S E R V I C E N O T E

**4396A Network/Spectrum Analyzer**

**Mod. corrects "PHASE LOCKED LOOP UNLOCKED" at high temperature**

**Fig.1 Parts Locations**

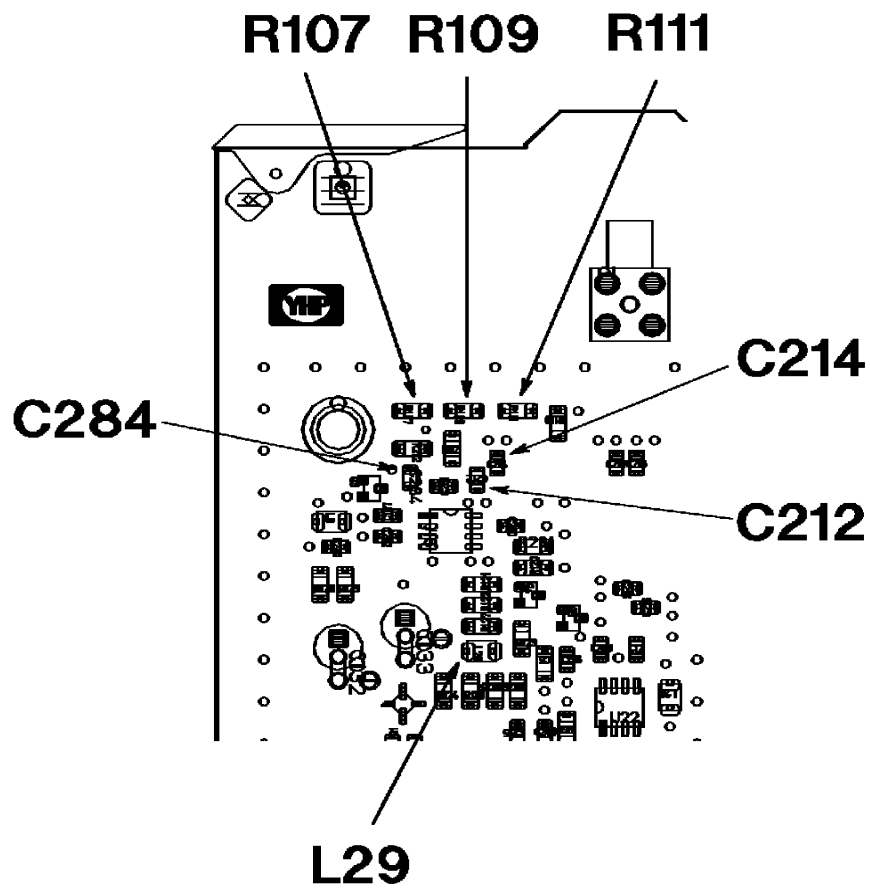
1. "PHASE LOCKED LOOP UNLOCKED" error occurred at high temperature.
2. Internal Test 8: A5 STEP OSC failed.

Replace or delete the following parts on the A5.

<b>Ref. Desg.</b>	<b>Action</b>
C212	Replace with 0160-5971
C214	delete
C284	replace with 0160-5971
R107	replace with 0699-1364
R109	replace with 0699-1352
R111	replace with 0699-1362
L29	replace with 9140-1202

Fig. 1 identifies the location for these parts.
